Bulletin No.: 15166B  
Date: April 2015

# Recall Bulletin

**SUBJECT:** Rim Size Missing on Certification Label

**MODELS:** 2015 Buick Encore  
2015 Chevrolet Trax

4152238

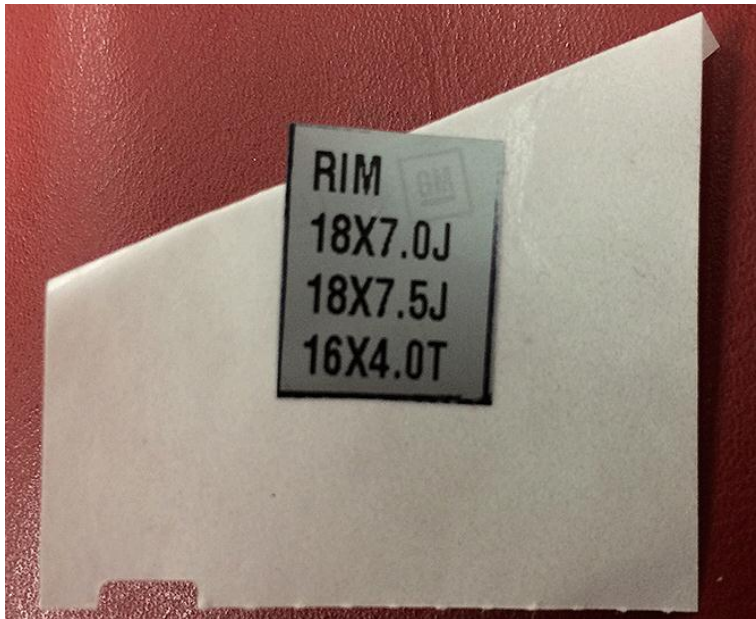
3. The original label may be blank under the "RIM" column, or have information hand written in. If the label is hand written, you may remove the writing with isopropyl alcohol (rubbing alcohol) before applying the overlay.
4. The original label must be clean and dry before installing the overlay label.

Dealers are to order and apply an overlay label to correct the rim dimension information on the vehicle certification label following the instructions below. All affected vehicles must receive an overlay label even if the information was previously “written-in” per the instructions in bulletin 15166A.

4152227

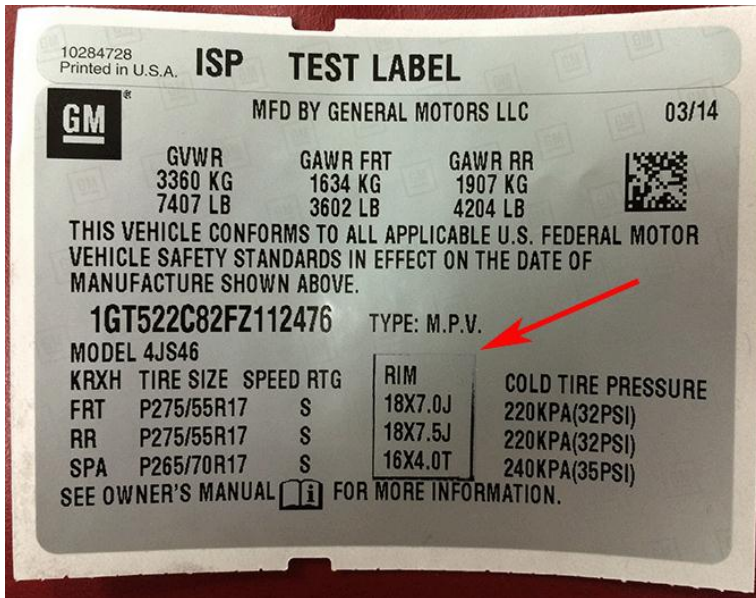
5. Locate the overlay label included with these instructions. Remove the label from the backing by folding the backing paper as shown above.

6. Apply the overlay label in the location shown above. Assure the label is properly positioned before allowing contact with the original label. The adhesive used is very aggressive and will not allow repositioning once the label is applied.
7. Close the driver's door.
